Township of Lawrence ENGINEERING DEPARTMENT

Minor Subdivision w/ Variance Application No. S-2/23

<u>Stefani DeClercq</u>, 119 Federal City Road Tax Map Page 44, Block 4401, Lot 9.01

Minor Subdivision Application

4.0 Subdivision Plan Comments

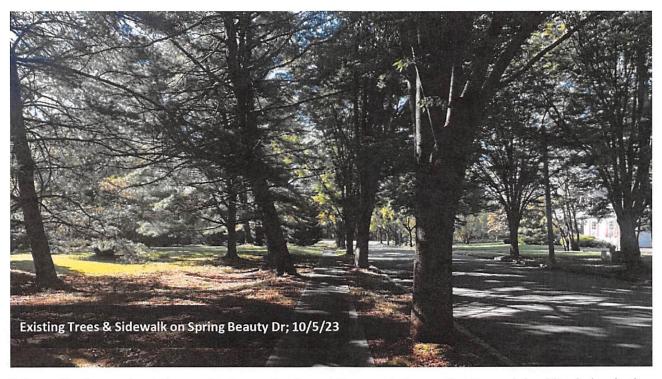
4.1 Testimony should be provided regarding all site improvements and demolition. It appears the Applicant is proposing to demolish the existing sheds and in ground pool.

- 4.2 Testimony should be provided regarding the existing vegetation on the site, and should include whether any trees are proposed for removal. There are several mature trees along the frontages of the property. A tree protection zone, pursuant to §541E, should be depicted on the plot plan, along with any associated tree protection fencing.
- 4.3 Testimony should be provided regarding the environmental constraints on the property and the Applicant should confirm no disturbance to the environmentally sensitive areas is proposed.
